RFP Title: Site Improvements at Gano Street Park

Addendum #: 1

SITE IMPROVEMENTS AT GANO STREET PARK

November 13, 2024

L-1

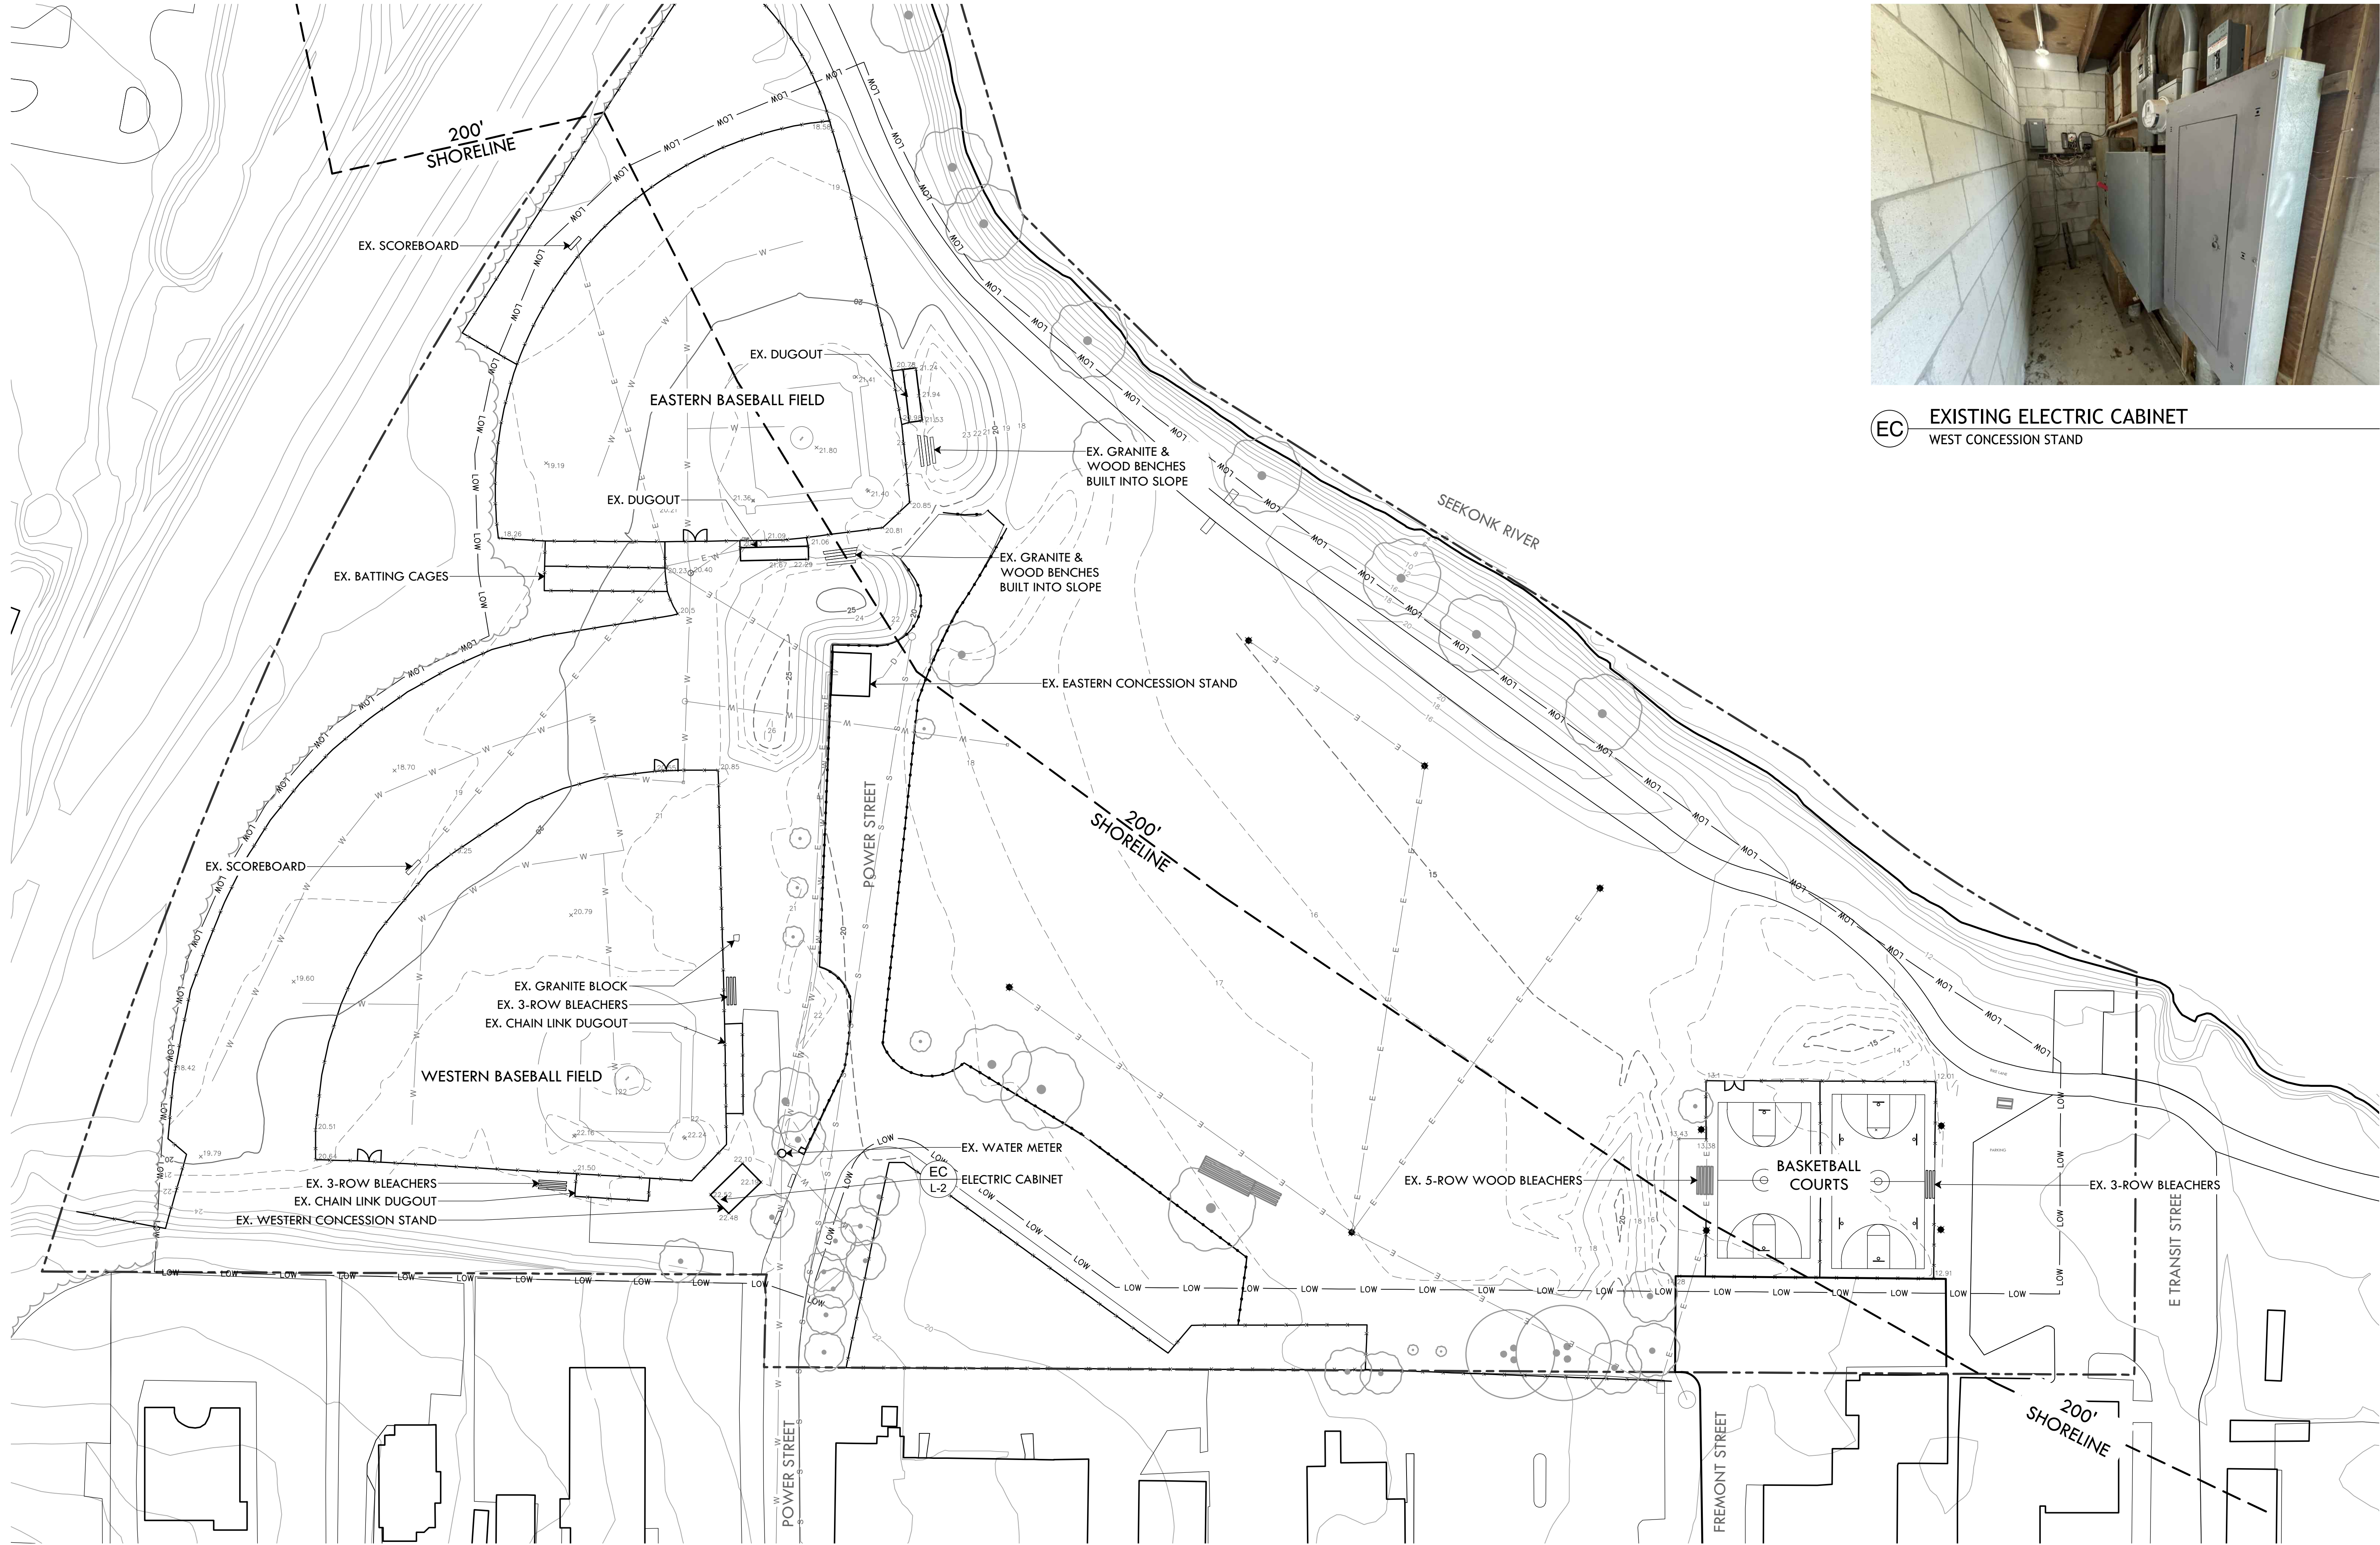
1. RFP p. 41, item #38 has been amended.
2. RFP p. 45, Drawings sheet schedule has been updated to reflect total number of sheets of lighting plans.
3. Technical Specifications for Site Furnishings have been updated to include dugout player's bench specifications.
4. Revisions made on plan set including sheets L-1, L-6, L-9, L-10, and L-11.
